August 13, 2009

**Re: Storm Water Inspection at the Village of Colonial Woods, Phase I and II  
Permit #4GC01894\*AG**

**Figure 1**

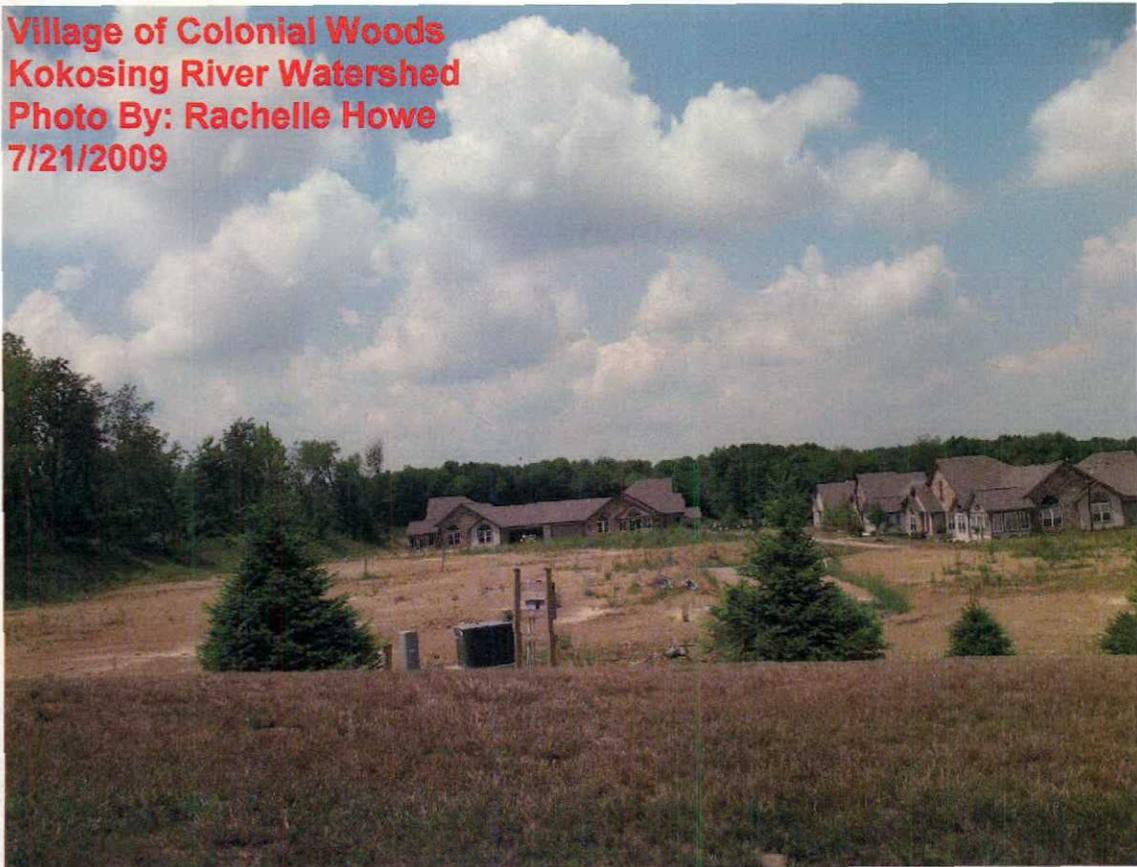
- Vegetative density is insufficient to protect against erosion (See Photo Figure 1). Please take corrective measures to achieve the required 70 percent vegetative density.
